ECE/TRANS/WP.29/GRE/2009/46
16 July 2009

Proposal for draft 01 series of amendments to Regulation No. 112
(Headlamps emitting an asymmetrical passing beam)

Submitted by the expert from the Working Party "Brussels 1952" */

Figure A: Spherical Coordinate Measuring System

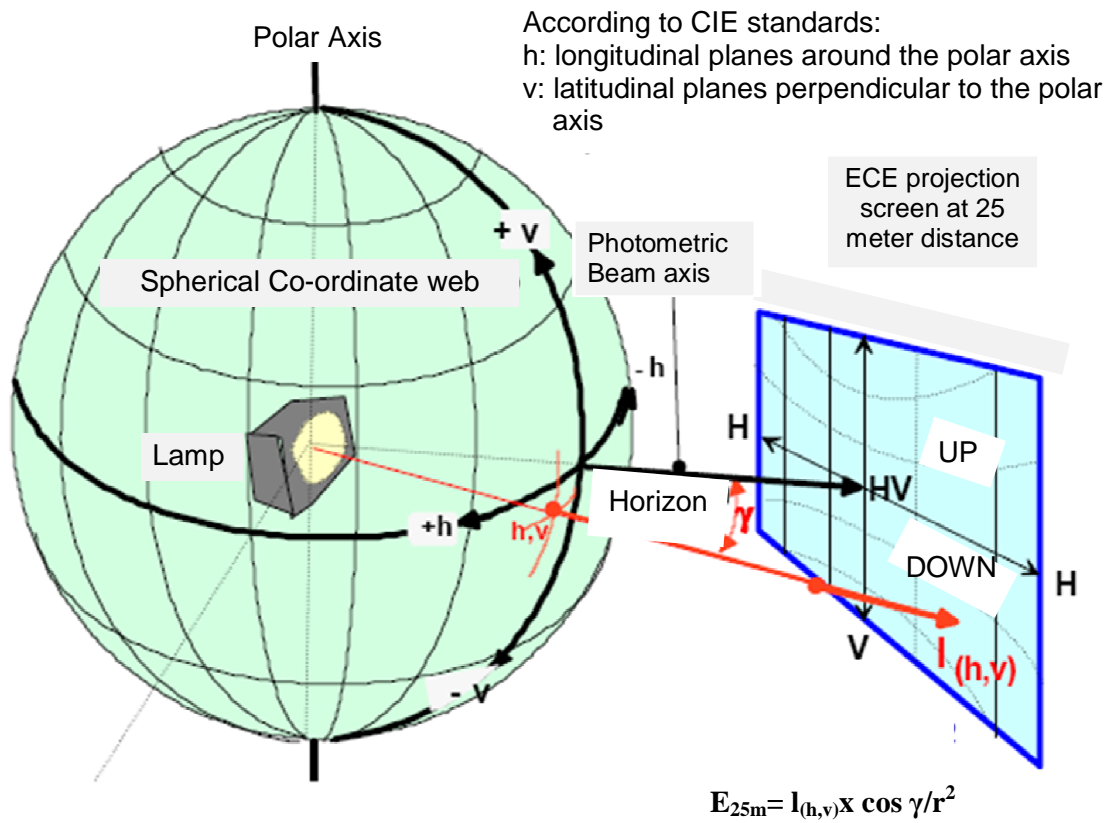
Annex 3, amend to read:

SPHERICAL COORDINATE MEASURING SYSTEM AND TEST POINT LOCATIONS

Figure B: Passing Beam for right-hand traffic

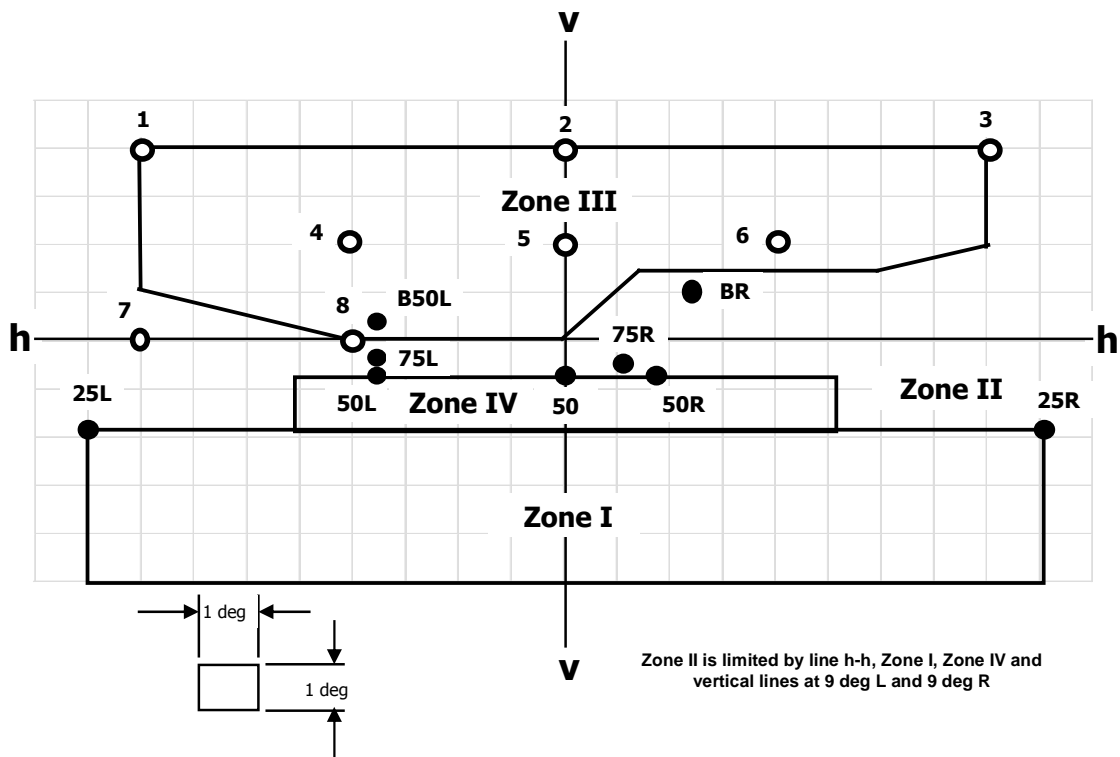
"6.2.4. **The passing beam shall meet the luminous intensities at the test points referred to in the tables below and in Annex 3 figure B (or mirrored about the VV line for left-hand traffic):**

The test point locations for left-hand traffic are mirrored about the VV line

Figure C: Driving Beam

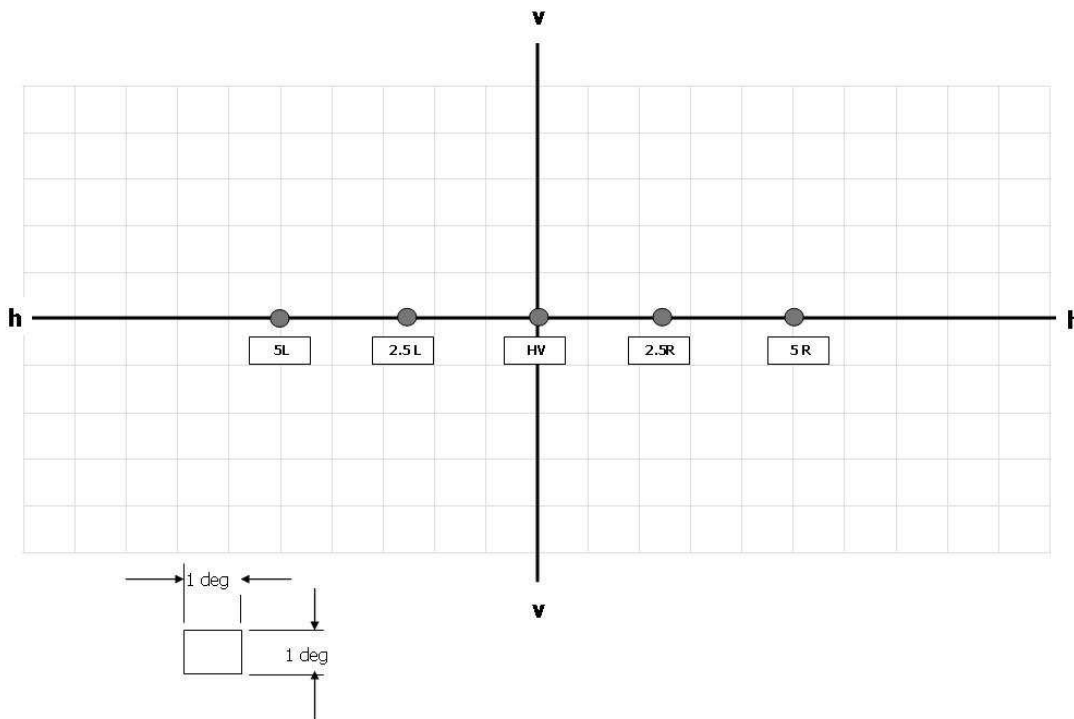
"6.3.3. Referring to Annex 3 Figure C and the table below, the luminous intensity distribution of the driving beam shall meet the following requirements:
